Service Bulletin

Bulletin No.: 23-NA-209

Subject: Oil Can and/or Pop Noise from Roof Area During Car Wash

Brand:	Model:	Model Year:		VIN:		Engine:	Transmission:
		from	to	from	to		
Chevrolet	Colorado	2023	2024	-	-	All	All
GMC	Canyon

6484170

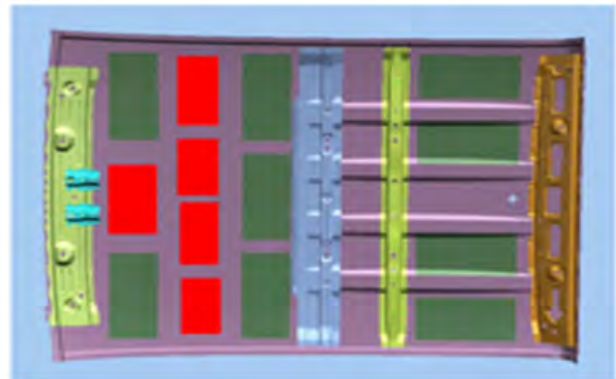
Involved Region or Country	North America
Additional Options (RPOs)	Excluding all vehicles equipped with Sunroof (RPO -CAC)
Condition	Some customers may comment on a oil canning or popping noise originating from the roof area during or after a automatic car wash.
Cause	The cause of the condition may be force from some air dryers at a automated car wash can cause flex in the roof panel, causing a loud oil canning type sound.
Correction	Repair any damage done during the event and apply stiffening patches to the underside of the roof panel following the procedure listed below.

- Once the headliner is dropped (but not removed) apply the 5 stiffening panels to the underside of the roof panel in the **RED** locations in the illustration above.
- Once the panels are installed, reinstall the headliner. Refer to *Headlining Trim Panel Replacement* in Si.
- Verify the condition is corrected.
